**PLANNING  
COMMISSION  
STAFF REPORT  
SEPTEMBER 19, 2023**

**Application Number:** 23PLN-24  
**Subject:** Development Review Permit for site landscaping, ±4,800 square feet of outdoor seating area, master sign program amendment, and mural proposal  
**Location/APNs:** 111, 117, 129 and 151 W McKnight Way/029-350-07 & 09  
**Applicant:** Mesa Management  
**Representative:** Jeff Fitzpatrick, Solutioneer  
**Zoning/General Plan:** Central Business (C-2)/Commercial  
**Entitlement:** Development Review Permit  
**Environmental Status:** Categorical Exemption

**Currently proposed boardform wall in front of “the Mix” and “the Midway” outdoor dining area**

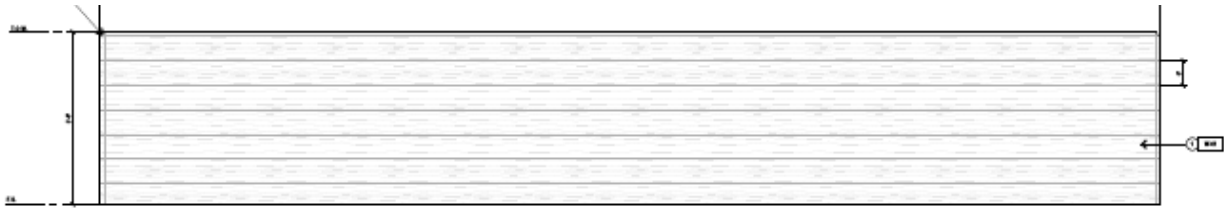
The Mix: The originally approved plans included a ±2,500 square foot outdoor dining space in the southwest corner of the shopping center, identified as “the Mix.”. The dimensions of the space are the same, but the architectural elements have changed, primarily with respect to the front barrier, which is now proposed to be a boardform wall instead of a Corten-framed mesh fence with climbing vine, and with respect to signage which was originally to be an overhead structure supported by a heavy timber frame, and is now a 12-foot high, stylized monument sign made of wood and metal (image in next section of this report). The Mix space will also feature two substantial steel-framed shade structures with corrugated steel roofing, which will support festoon lighting that spans the outdoor space. A sculpture garden is also proposed, featuring miners and a mule.

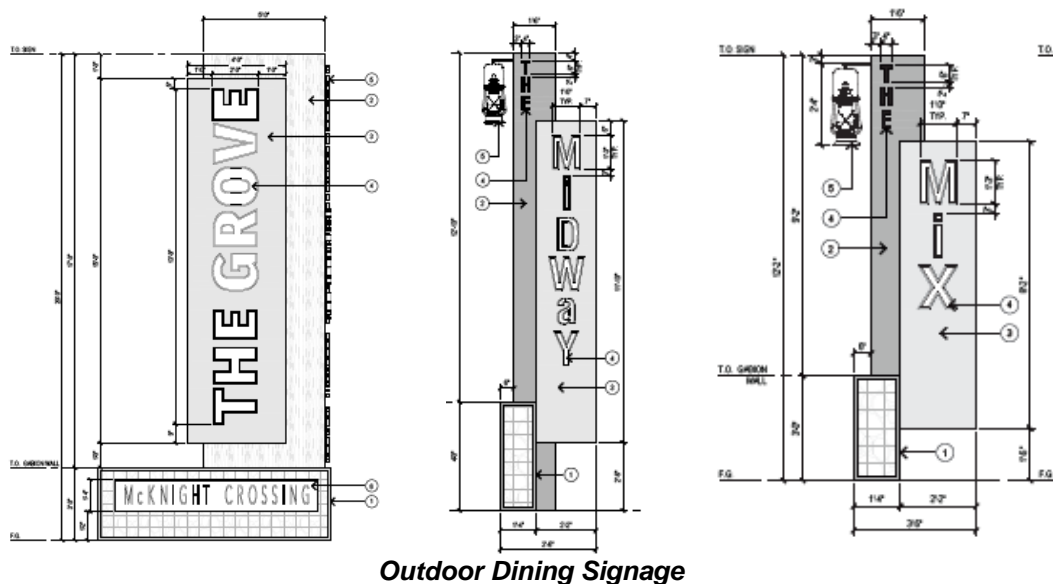
**Lighting:** Several dining spaces feature festoon lighting, which is typically inconsistent with the city’s standard to be “shielded or recessed” and several callouts on the plans indicate that particular lighting fixtures will be selected by a lighting consultant. The DRC made a recommendation that the commission find that the unshielded festoon lights meet the intent of the city’s shielding requirement, provided that the lights have a lumen level less than 100. Condition no 5 is included if the planning commission is comfortable making the same finding. Staff has included condition of approval no 9, requiring that the applicant provide all proposed lighting styles to the Planning Department for review prior to installation and that they may be approved so long as they are consistent with the standards outlined in section 17.30.060 GVMC, including shielding of festoon lighting.

9. Prior to installation, the applicant shall provide all lighting styles to the Planning Department to review for consistency with standards outlined in section 17.30.060 GVMC, including shielding of festoon lighting.

**Currently proposed signage for Taylorville entrance.**

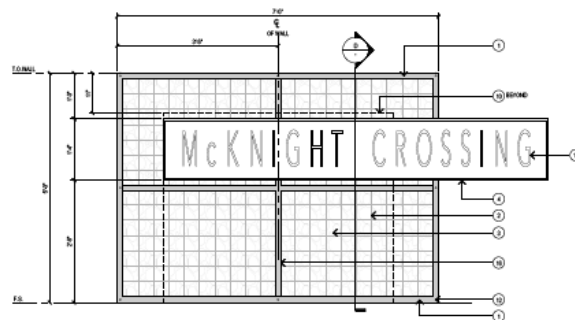
Since that approval, the applicant has determined that branding for the Mix, the Midway, and the Grove will be useful to distinguish each of the outdoor dining spaces. To that end, they have proposed stylized monument signage with heights ranging from 12 to 20 feet at each of these locations. They have applied the same style of signage to a proposed "McKnight Crossing" entrance sign at the Taylorville Road entrance, which is a deviation from the style of signage already constructed at the two McKnight entrances. The stylized signs will bring cohesion to the center across the four parcels and may also serve as navigation markers for shoppers. The attached master sign program amendment includes language in support of each of the proposed signs and omits directional signage at the Taylorville entrance that is no longer proposed. Per discussion by DRC, the applicant was asked to relocate "The Grove" sign, away from the drive aisle a couple feet in order to avoid site distance interference (see condition no. 11)

11. The applicant shall relocate "The Grove" sign, away from the drive as much as practical in order to avoid site distance interference.
12. The applicant agrees to defend, indemnify, and hold harmless the City of Grass Valley in any action or proceeding brought against the City of Grass Valley to void or annul this discretionary land use approval.
